SEWAGE DISPOSAL SYSTEM

HOWARD COUNTY HEALTH DEPARTMENT

Arnold Backhoe & Septic Serv	ices IS PERMITTED TO INSTALL X	_ALTER
ADDRESS P. O. Box 15, Woodbine	, Maryland 21797 PHONE 795-787	3
SUBDIVISION Brierly	LOT 8ROAD13841 Russell Zepp	Drive
PROPERTY OWNER	Lesley and Deborah Barker	
ADDRESS		
SEPTIC TANK CAPACITY	*Need 1500 gal. top seamed 2 compartment so pump system. Use a 1500 gal. pump chamber for pump chamber detail showing on/off ala settings and storage capacity above high w	or submit pla rm float
TRENCHES - Trench to be 2 depth 7 feet b	feet wide. Inlet 4 feet below original grade. Blow original grade. Effective area begins at 4 : 3 feet of stone below distribution pipe.	Bottom maximum
LOCATION - Beginning from begin trenches	the intersection of the 191.91' lot line and 272 70' up the 272.81' lot line and -50' off that say	.81' lot line
NOTES - No trench to e	ches on contour in both directions.  Sceed 100 feet in length Provide 6" - 8" diameter  de or above on septic tank.	er cleanout

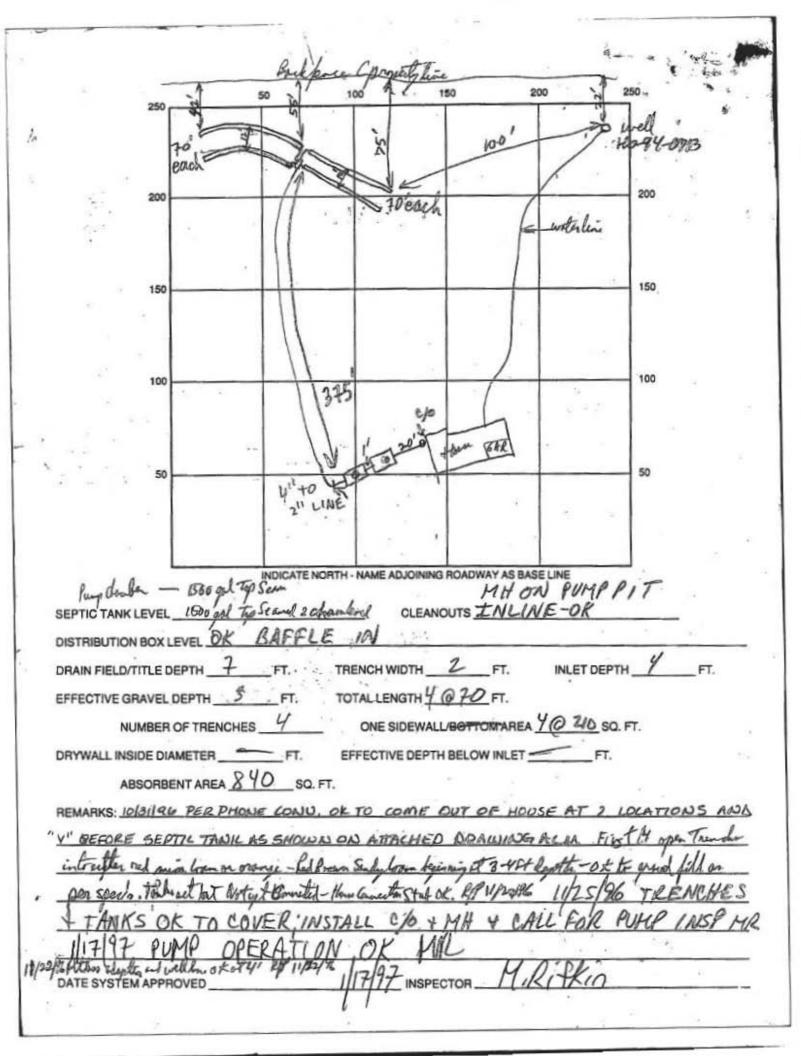
AND POTUGUES	
PLANS APROVED BY Amy McMillen	AND RETURNED 5-25-25 SOUTH BY 0 1/2037 DATE	7/25/96
COVER NO WORK UNTIL INSPECTED AND APPROVE	ditaried garden shed	UZ
